TO: Transportation, Infrastructure, Energy and Environment Committee
FROM: ^{GO} Glenn Orlin, Deputy Council Staff Director
SUBJECT: Facility planning review—East Gude Drive

RE: East Gude Drive Phase I Transportation Facility Planning Study
Crabbs Branch Way to Southlawn Lane
Project Prospectus

SUBJECT: East Gude Drive Phase I Transportation Facility Planning Study
Crabbs Branch Way to Southlawn Lane
Project Prospectus Recommendations

Figure ES-2a. Alternative 3: Enhanced Master Plan, Recommended Alternative. Proposed typical roadway along East Gude Drive at Section A-A, approximately 1,000' east of Calhoun Drive.

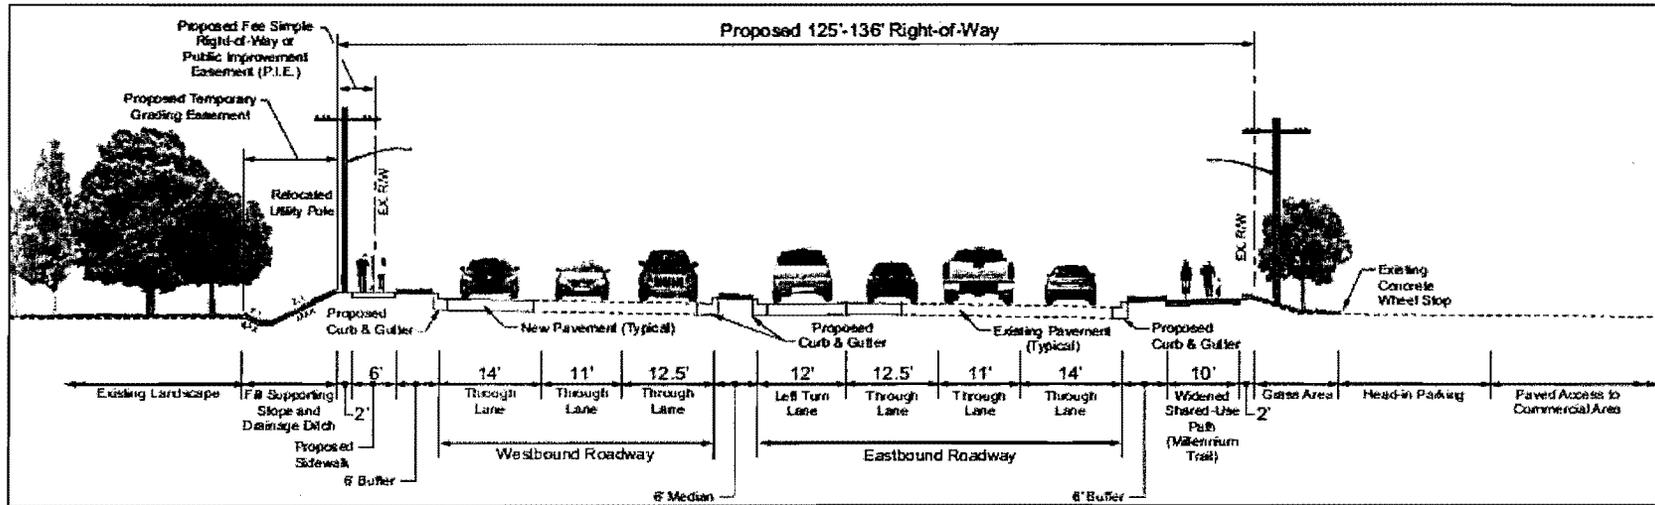
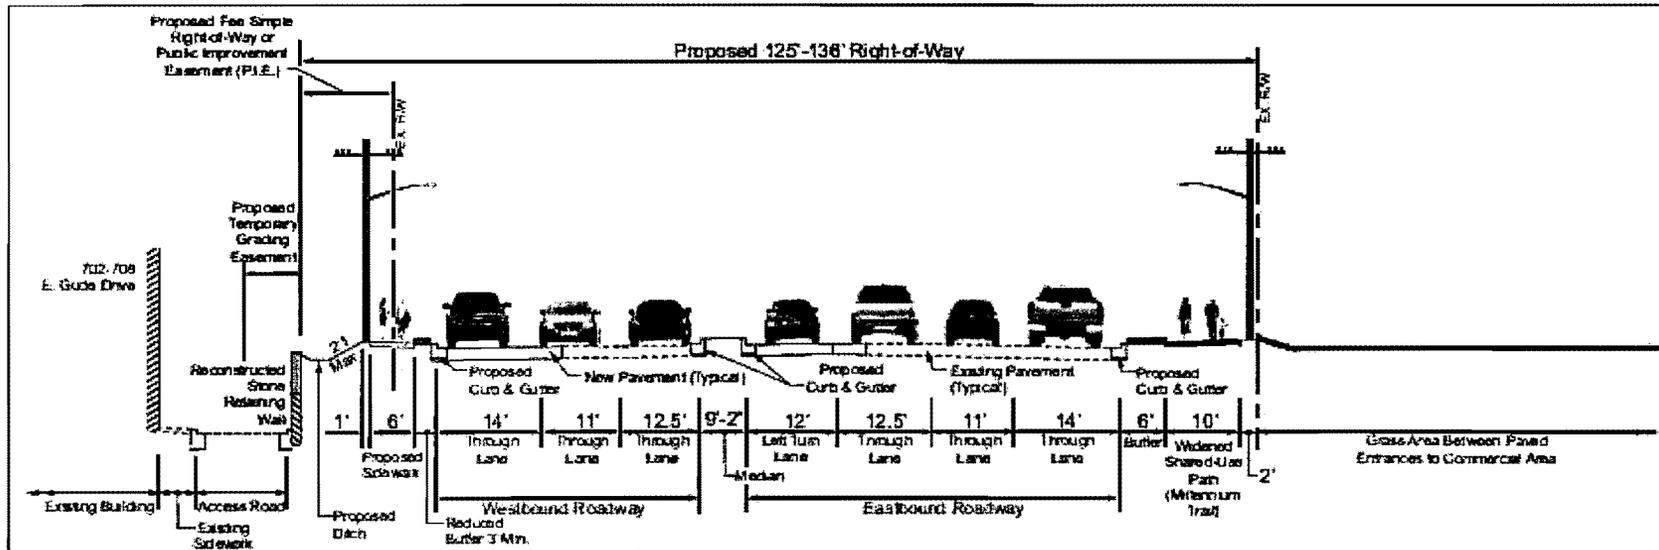
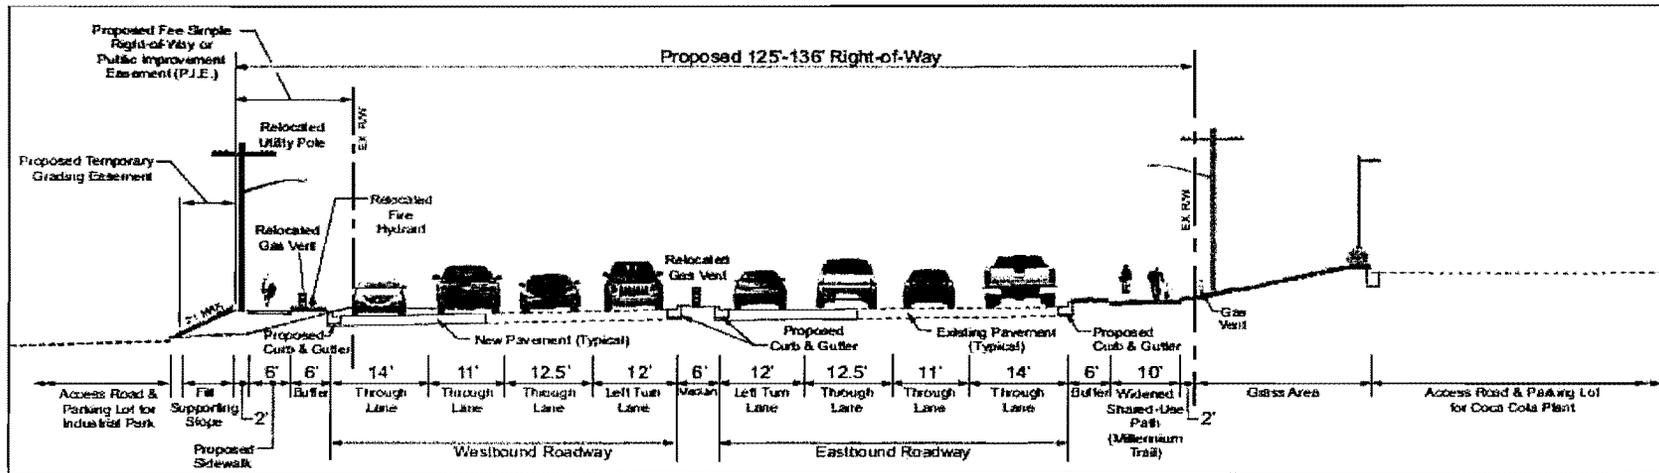
Council staff’s recommendation is consistent with the current Upper Rock Creek Area Master Plan. It does not include some other aspects of Alternative 3 that are less important: adding through lanes where they are not needed in the next 20 years, widening the lightly used (in this segment) Millennium Trail and setting it back 6 feet from the edge of the roadway, connecting missing sidewalk links on the north side (there is the continuous hiker-biker trail on the south side), and some smaller improvements. Note the comment included in the prospectus from a member of the Rockville Bicycle Advisory Committee, who suggests if the project must be down-scaled his choice would be first to trim the north-side sidewalk and second to not add the 6’-wide buffer for the Millennium Trail (©27).

i am a member of the Rockville Bicycle Advisory Committee and have been informed by our City liaison R.Torma that feedback concerning the study for improvements to the part of E Gude inside the County are requested. Having studied the PDF link concerning the proposed improvements I have nothing to request for additional inclusion. I will comment however concerning possible down-scaling. If the project needs to be trimmed, trim first the sidewalk on the North side. Second the 6' buffer between the millennium trail and the roadway. Third the additional westbound lane. Fourth the extra wide 14.5' outer lanes.
